COMMISSION OF ARCHITECTURAL REVIEW STAFF REPORT May 26, 2015 Meeting

9. CAR No. 15-060 (Q. King)

916 N. 25th Street Union Hill Old & Historic District

Project Description: Replace front porch railings, columns, and handrails and replace windows

916 N. 25th St - August 2014 (Google Streetview)

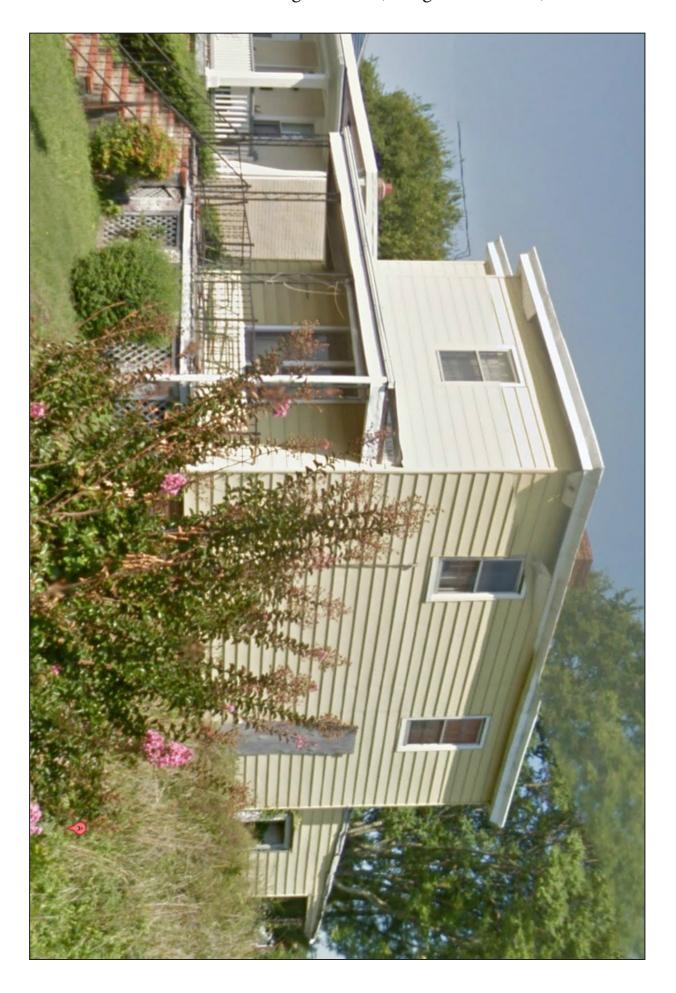
In March 2015, the applicant was issued a Notice of Violation for the installation of vinyl porch railings and handrails without a Certificate of Appropriateness. The original railings, handrails and columns were black metal and not original to the property. The new railings and handrails are white vinyl with exterior fasteners. The new columns are square posts painted gray to match other trim on the porch. The applicant states that the prior railings and handrails were installed approximately 30 years ago, and the new vinyl railings and handrails were an attempt to replicate something similar to what was historically installed but with increased durability.

In discussing the railings and handrails with the applicant, it came to staff's attention that several historic windows were replaced on the structure as well. The applicant states that the original 6/6 wood windows were in poor condition. Many were inoperable and were missing glass panes. The new windows are Pella windows which are 6/6 grid-between-the-glass vinyl windows. In total, six windows were replaced, two each on the front, rear, and right 2nd floor. The applicant is also proposing to replace the other existing historic windows on the structure.

Staff does not recommend approval of the project. The *Richmond Old and Historic Districts Handbook and Design Review Guidelines* states that, "When designing a new railing for a new infill building, or for an existing building which has lost its railing and for which no documentary or physical evidence survives, the balusters in the traditional Richmond rail are generally rectangular in section or square," and that, "Richmond railing is a painted wood railing with the following components: a molded handrail, a series or regularly spaced rectangular pickets that fit in a groove in the top and bottom rails, and a molded bottom rail" (p.46 #2 & Appendix: Glossary). The *Guidelines* also state that, "The use of synthetic materials that will alter the appearance, proportion, and/or details of an historic structure is strongly discouraged" (p. 56).

In regards to the replacement windows, the *Guidelines* state that, "Windows should only be replaced when they are missing or beyond repair. Any reconstruction should be based on physical evidence or photo documentation," and that, "Because the material cannot be manufactured to model effectively the appearance of historic windows, vinyl windows are not appropriate for historic buildings in historic districts" (p. 65 #7 & 11).

Staff does not recommend approval of either portion of the application. Both the replacement railings and handrails and replacement windows are not supported by the *Guidelines*. Staff would typically recommend wooden railings and handrails designed in a Richmond rail style, as well as wood or aluminum-clad wood windows with true or simulated-divided lites. Staff has no issue with the square, wood columns that were installed and painted gray to match other elements of the front porch.

Staff recommends that the applicant return to the Commission with a new porch railing and handrail design that is in keeping with the *Guidelines*, as well as a more appropriate type of replacement window. In regards to the applicant's proposal to replace the remaining historic windows, staff recommends that the applicant return to the Commission with a full window survey of the remaining windows, showing photographic evidence from the interior of the structure that the windows are beyond the point of repair. In regards to windows and doors on the 1st story rear elevation, these are not visible from the public right-of-way due to the lack of an alley behind the property and the presence of a privacy fence. Therefore, the Commission does not have control over these specific elements.
